# National Energy Board Report

**NOVA Gas Transmission Ltd.**

**GH-001-2014**

Application dated 8 November 2013 for the  
North Montney Mainline Project

**Figure 3-1: FT-R Rates in 2018 and 2019**

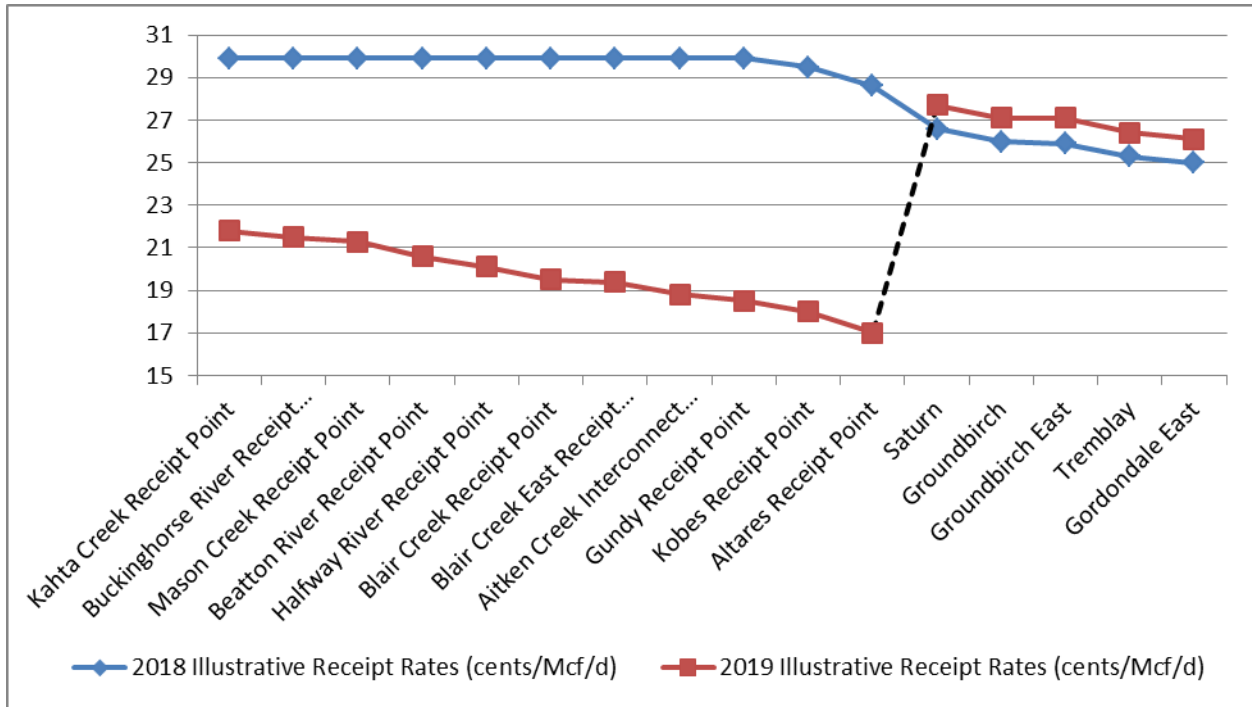
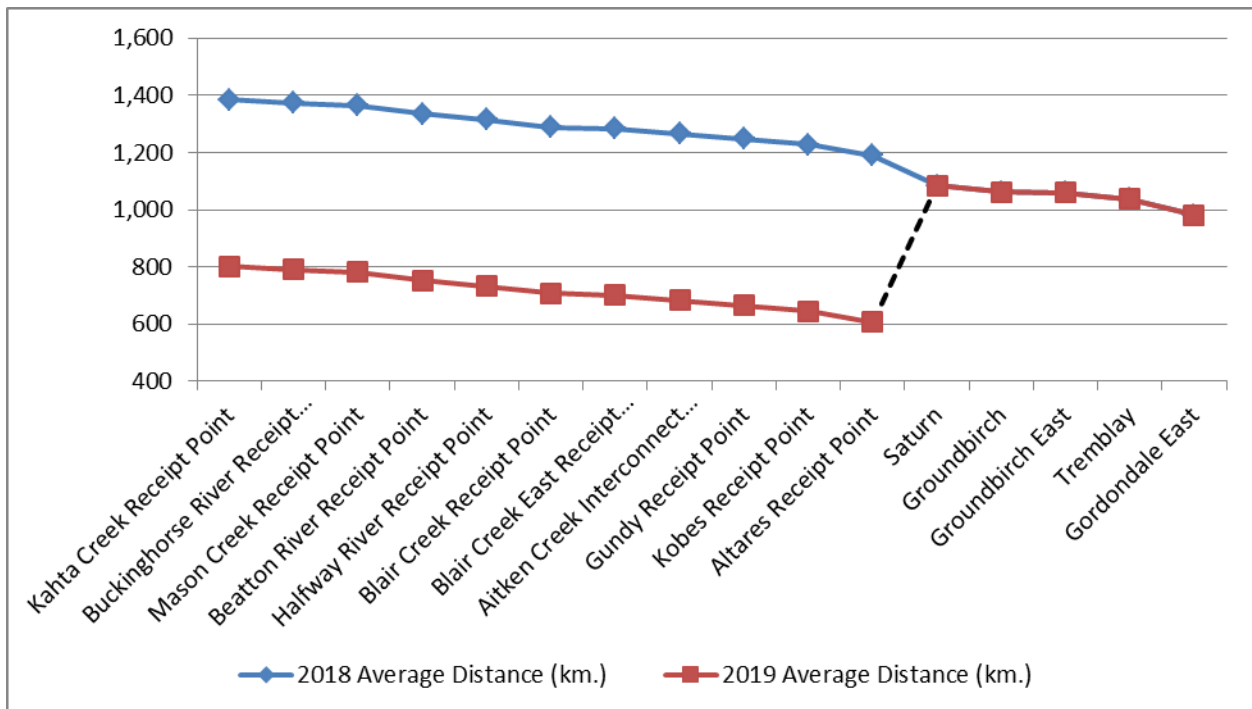
The proposed tolling methodology for the Project also generates receipt tolls with problematic patterns for the Long-Term Phase. Using selected data from the Application, Figure 3-1 presents the FT-R toll at various locations for 2018 and 2019 and Figure 3-2 presents the average path distances for various locations for 2018 and 2019. The estimated tolls for the receipt points on the Project during the Long-Term Phase exhibit irregular patterns when two Group 1 delivery points, Empress and Mackie Creek Interconnection, which are widely separated geographically, are part of the toll calculation.

The Board recognizes that NGTL estimated the receipt tolls for the Project without using the complete pricing algorithm. The Board finds that the illustrative tolls indicate that applying NGTL's current tolling methodology to this Project does not satisfy the cost causation principle in these circumstances. For example, Figure 3-1 shows that the tolls for the Project's Kahta Creek North Receipt Meter Station would be about 22 cents per Mcf in 2019 while the toll at the existing Saturn Receipt Meter Station on the existing NGTL System would be more than 27 cents. In contrast, Figure 3-2 shows that the average path distance for receipts from Kahta Creek North Receipt Meter Station would be about 300 km less than the path distance for the Saturn Receipt Meter Station. This results in the receipt tolls for Shippers A, B and C being very low relative to the tolls for receipt shippers on the existing NGTL System near Saturn.

**Figure 7-2: Alternative Route Options Considered by NGTL for the Aitken Creek Section**

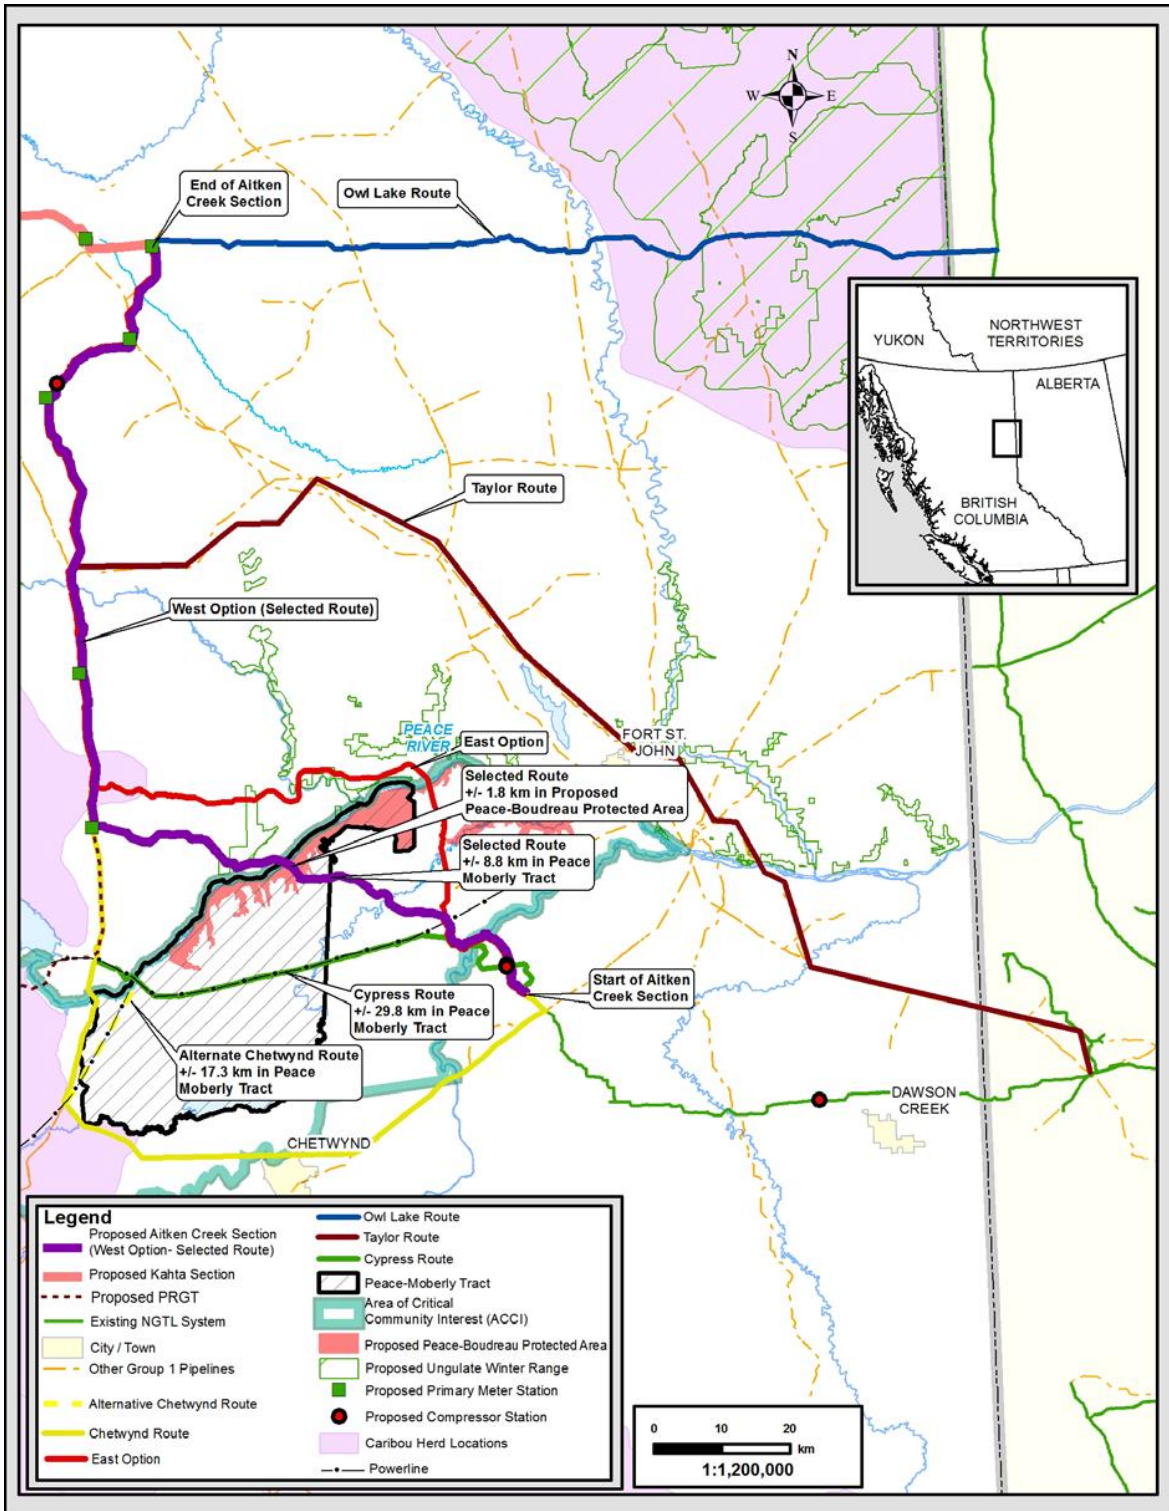
According to NGTL, in determining the preferred route for the Project, it considered the following routes: Cypress Route, Owl Lake Route, Tylor Route, Chetwynd Route and, the East and West Options (see Figure 7-2).

NGTL stated the final two route alternatives considered were the East and West options. NGTL stated the East option was initially preferred from the perspective of minimizing impact to culturally sensitive lands and the proposed Peace Boudreau Protected Area, and potential technical feasibility. NGTL submitted that the completion of boreholes and feasibility studies presented a very low probability for a successful crossing of the Peace River at this location. NGTL confirmed that it communicated to Aboriginal communities and stakeholders that the West route would be pursued for the Project, as it best balanced feedback from Aboriginal communities, technical feasibility, environmental impacts and commercial needs.

NGTL stated it has spent roughly four years evaluating routing options across the Peace River and believes that the proposed West option route is feasible and the most appropriate route for the Project because it minimizes impacts on the PMT and the overall length and footprint of the Project (including the footprint within caribou range) and meets the requirements of the Project.
